COA # 2014-COA-278 (HMP)	IND	DIANAPOLIS HISTORIC PRESERVATION COMMISSION	Hearing Date AUGUST 6, 2014
		STAFF REPORT	
1615 N. TALBOTT STREET HERRON-MORTON PLACE			NEW CASE
mailing address:		RADE DESIGN STUDIO 28 N. New Jersey Street lianapolis, IN 46202	
Owner:		MOS ALEXANDER 23 N. Talbott Street lianapolis, IN 46202	Center Twp. Council District 9 Joseph Simpson
NEW CASE			
IHPC COA: 2014-COA-278 (HMP)  Construct 4-car attached garage Enclose space between rear wings Remove two chimneys Remove two-story deck & door Remove second story deck & door Relocate two windows on north façade Replace front façade dormer windows Replace third floor door with windows Replace front door			
STAFF RECOMMENDATION: Approval of a Certificate of Authorization

## 2014-COA-278 (HMP):

Rear façade with porches and recess visible

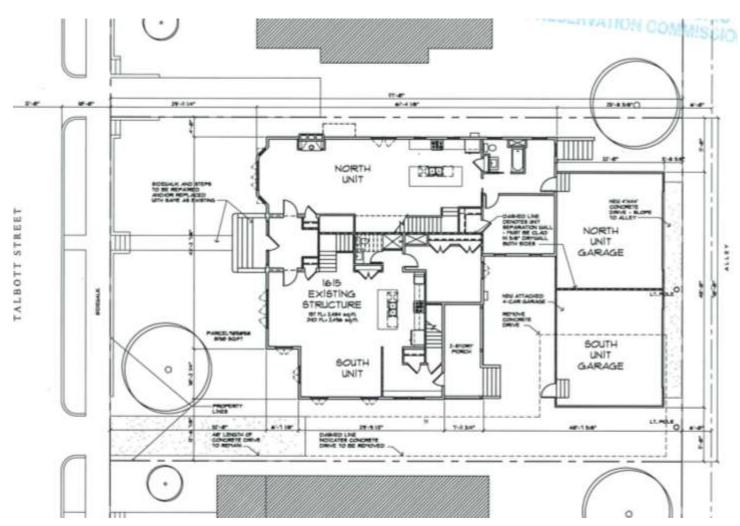
At the rear of the house is a small recess between two wings. It has an awkwardly shaped roof, and doesn't serve a particularly functional purpose. The intent is to salvage the wood shingles from this area, and enclose that space with a flush wall that will blend seamlessly with the main body of the house.

Inappropriate open decks were constructed at some point on the rear façade. These will be removed during the remodel. This also necessitates removal of access doors that lead out to the upper story decks. These will be covered by wood siding to match the surrounding siding. The first floor porch/deck will be retained and painted. Where missing trim board will be added to match the rest of the house.
